## FURTHER INFORMATION

**Proposed Hotel (Student Hostel) in “Other Specified Uses” annotated “Business” Zone  
and Area shown as ‘Road’, LT Tower, 31 Chong Yip Road, Kwun Tong, Kowloon  
(Kwun Tong Inland Lot No. 447)**

**(S.16 Planning Application No. A/K14/839)**

**Response-to-Comment**

# Plan 4g - FLOOR PLAN OF 11/F

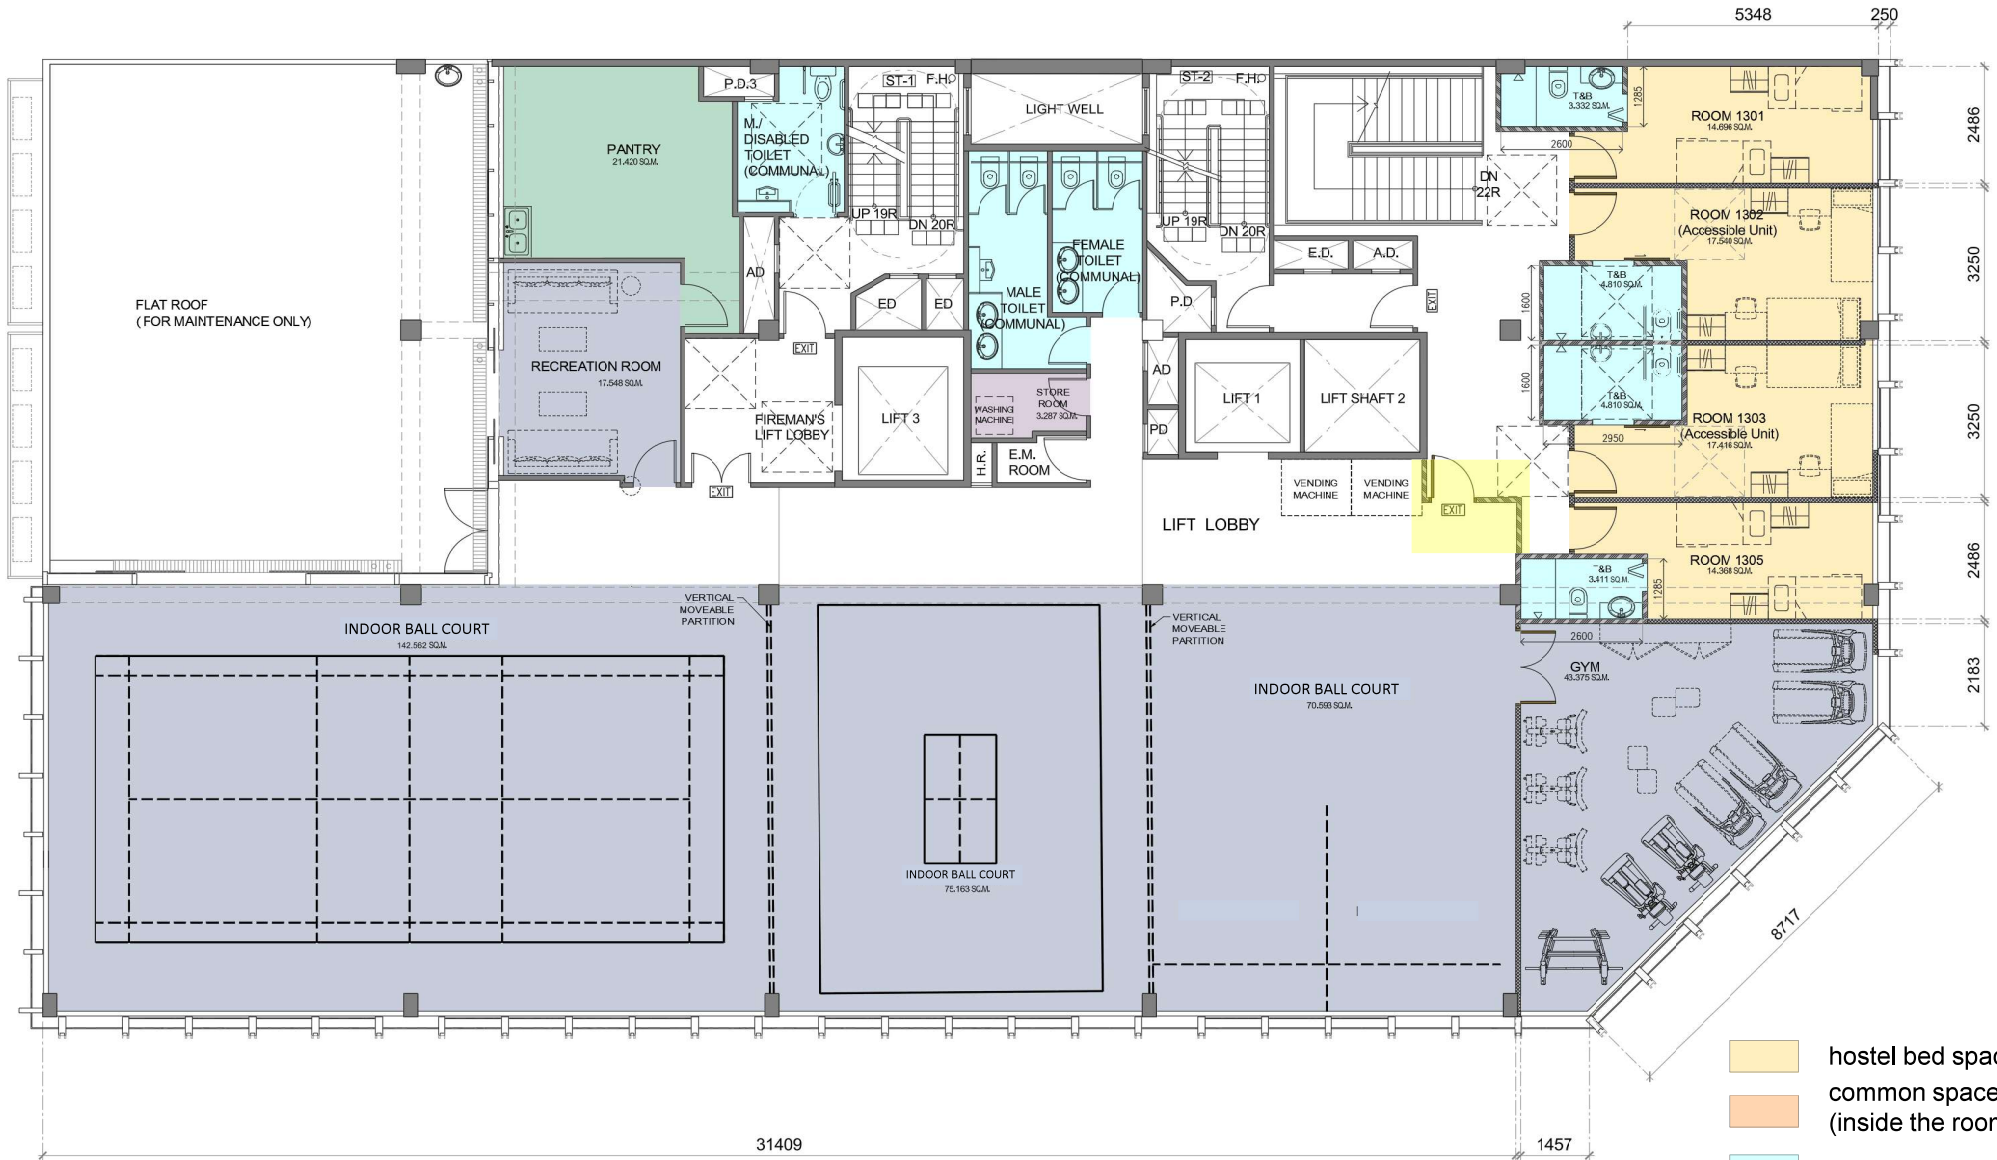
- (ii) The following minor revisions have been made on the floor plans:
- the window width measurements of Room 7 on 2/F-12/F and Room 8 on 2/F-9/F are shown on the respective floor plan of each floor (Plans 4c to 4h of **Annex 1**); and
